REMARKS

AMENDMENTS TO THE DRAWINGS:

Fig. 2

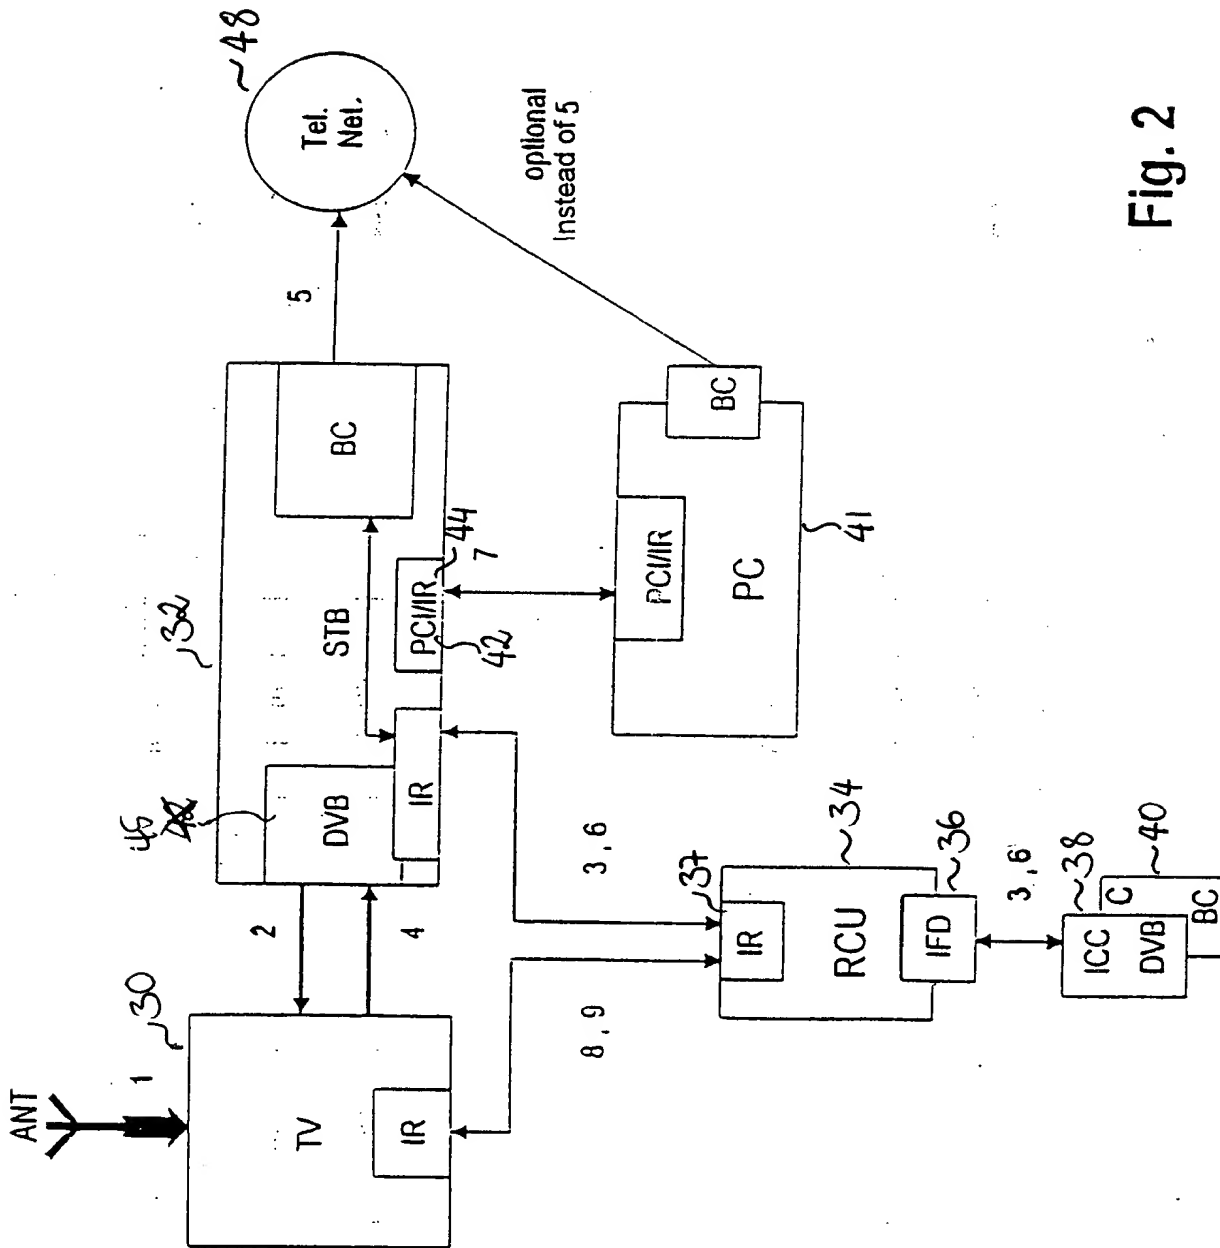
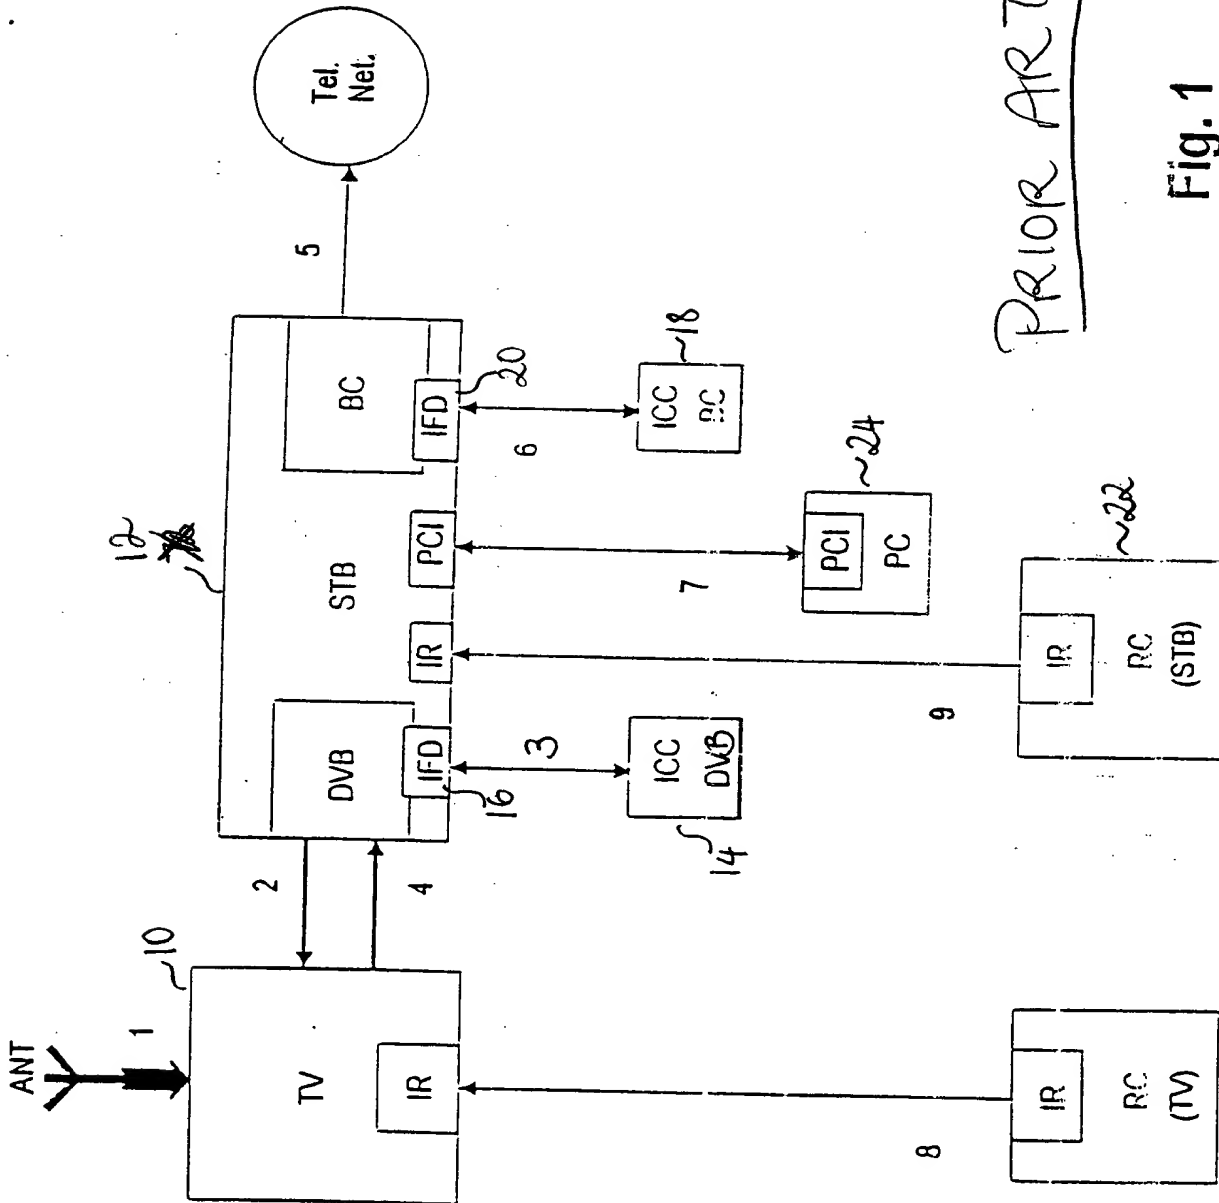
The attached sheet of drawings includes changes to Figs. 1 and 2. The sheets of Figs. 1 and 2 replace the original sheet of Figs. 1 and 2, respectively. In Fig. 1, STB “72” should read “12” in accordance with the Specification. Further, Fig. 1 should be labeled “Prior Art.” In Fig. 2, DVB “42” should read “45” in accordance with the Specification.
